Frequently Asked Questions

US 41 at Bonita Beach Road PD&E Study in Lee County

FPID 444321-1

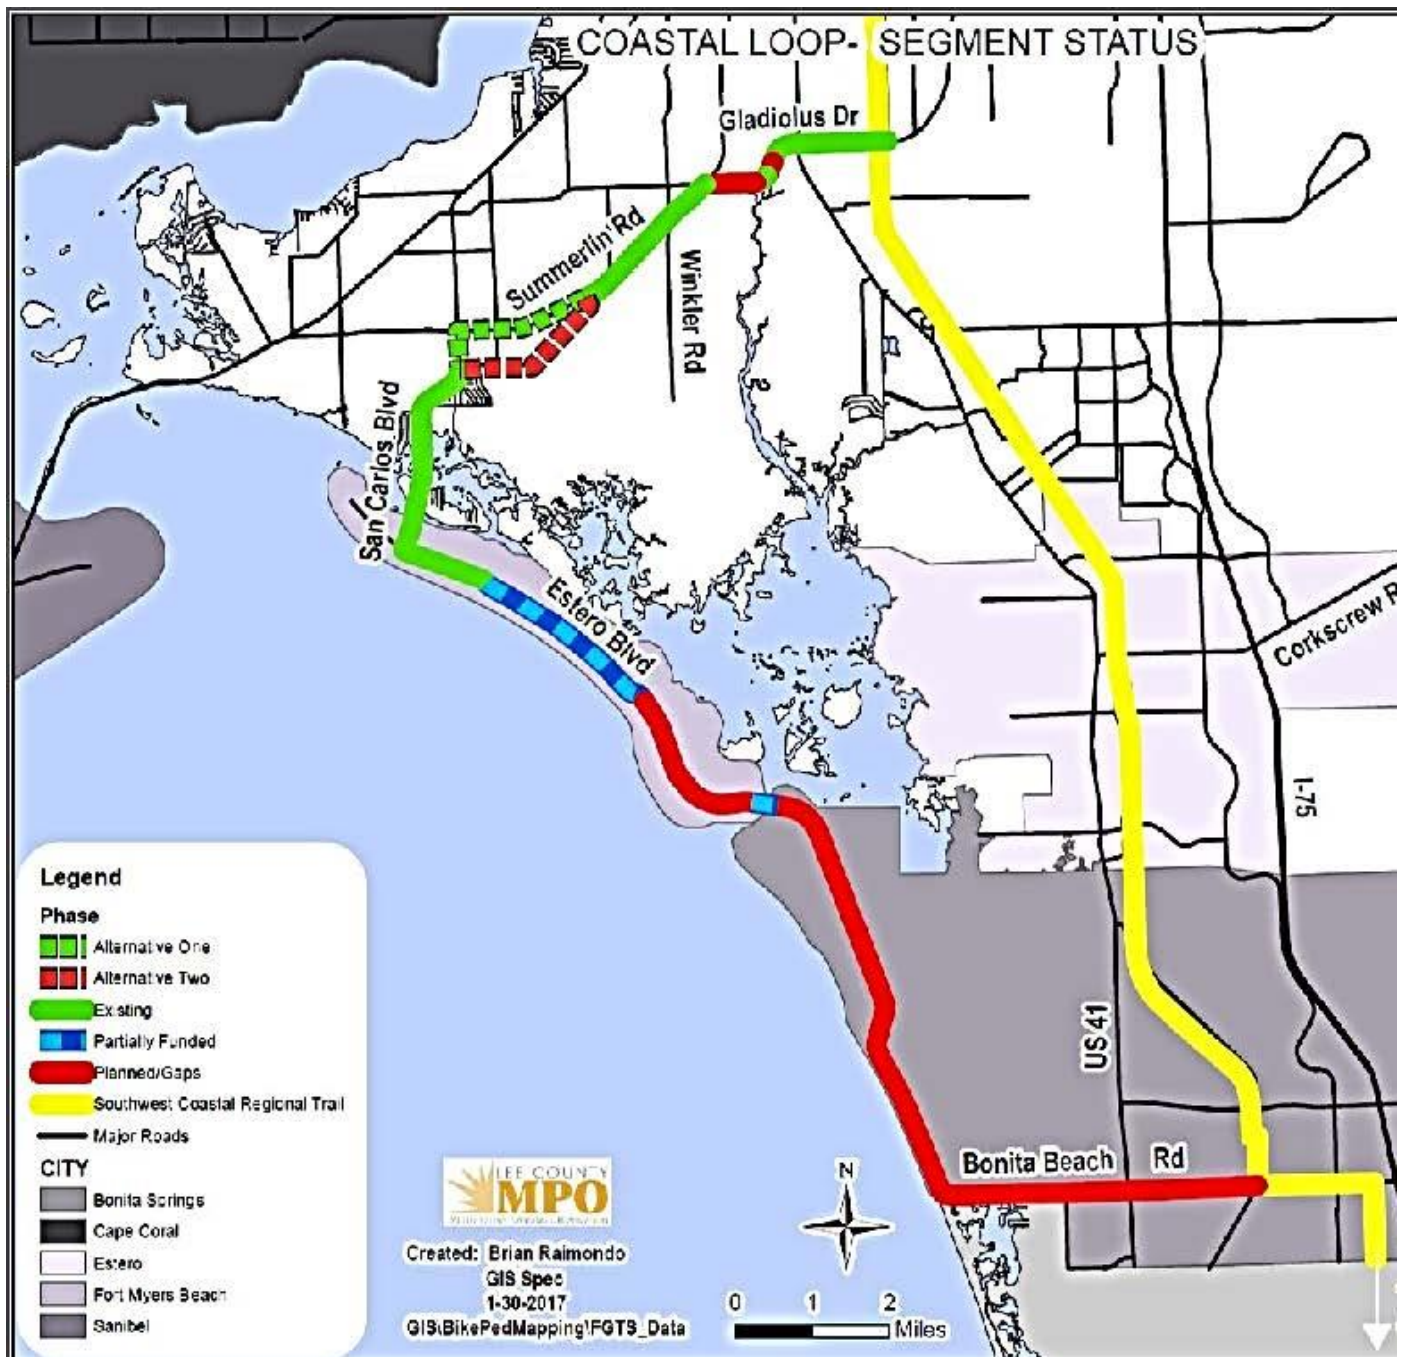
Question: How will Pedestrians and Bicyclists cross in the 8-Lane option?

Response: The intersection will have pedestrian crosswalks with countdown pedestrian signals for all intersection approaches. The signalized crosswalks will be timed to have sufficient time for a person to walk across all lanes.
